**TOWN OF CUTLER BAY
DEVELOPMENT REVIEW COMMENTS**

Application: *Site Plan Amendment*

Project Name: *Old Cutler Road Site Traffic Study*
Project Number: *14-7174*

Comments Based on 3rd Plan Submittal (Traffic Study dated July 2017) and Trip Generation Analysis dated 5-29-19

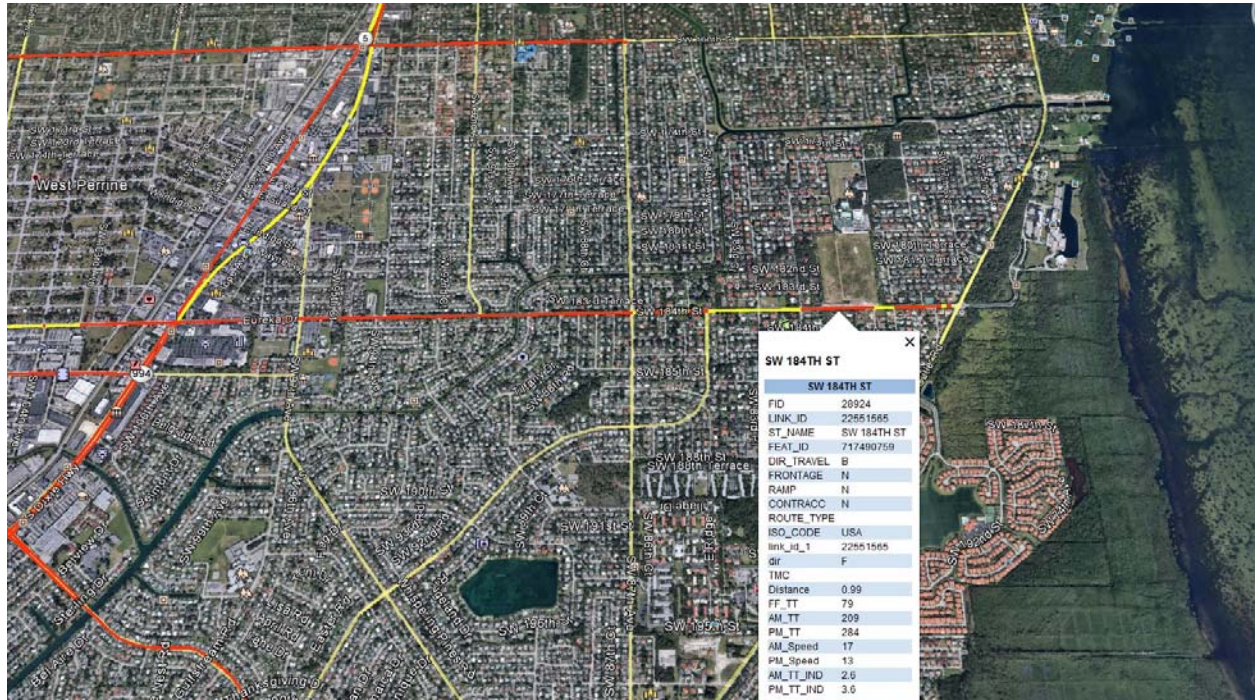
17. The Art Plan corridor analysis in the traffic impact study should include a sourcing of each of the input values that were used for each scenario. Please provide documentation in the Appendix for standard FDOT values for certain inputs if applicable (reference attached input reference sheet for typical inputs). Please ensure that data from the traffic counts collected (24-hour tube counts, manual turning movement counts) have been used to tailor each of the LOS corridor segment analysis. For instance, the percentage of left turns and right turns should correspond to the number of turns observed during the peak hour turning movement counts. The standard values per FDOT's

CGA 05/05/17 Response: Please update data in table for the %Turns from Exclusive Turn Lanes table.

DPA 05/17/17 Response: The requested data is included as Attachment B. The ArtPlan reflecting these factors is also attached.

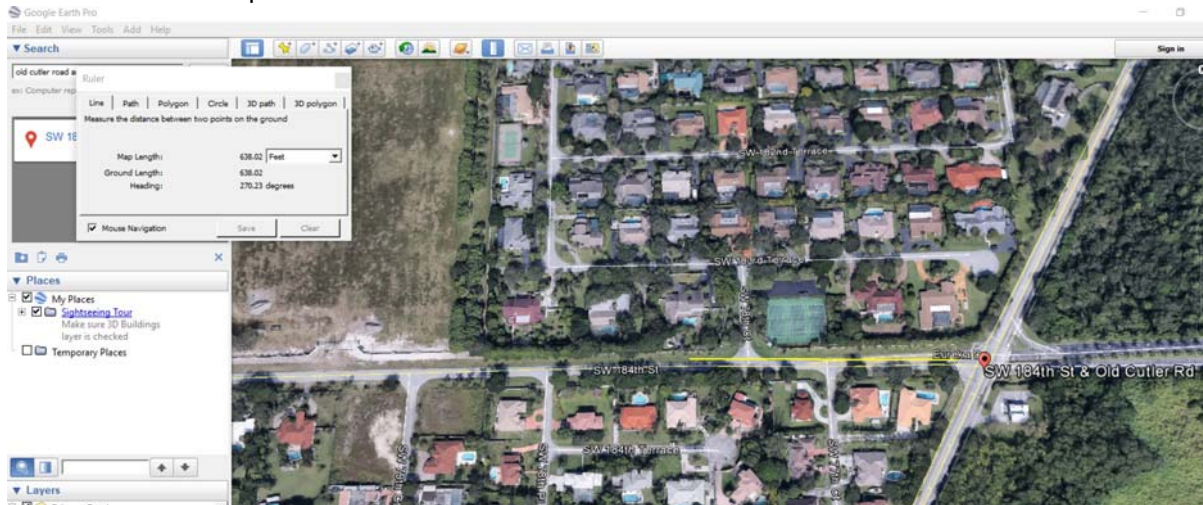
20. Please revise the FFS input in the Art Plan corridor analysis to be the posted speed limit. The roadway segments being analyzed are two lane facilities and the free flow speed will most likely top out at the posted speed limit and not 5 miles over the posted speed limit.

CGA 05/05/17 Response: Please update ArtPlan analysis to include the posted speed limit in the input for the free flow speed (FFS).

DPA 05/17/17 Response: The posted speed limit is included in the Segment (auto) input of the software. The output converts the speed limit to free flow speed automatically.
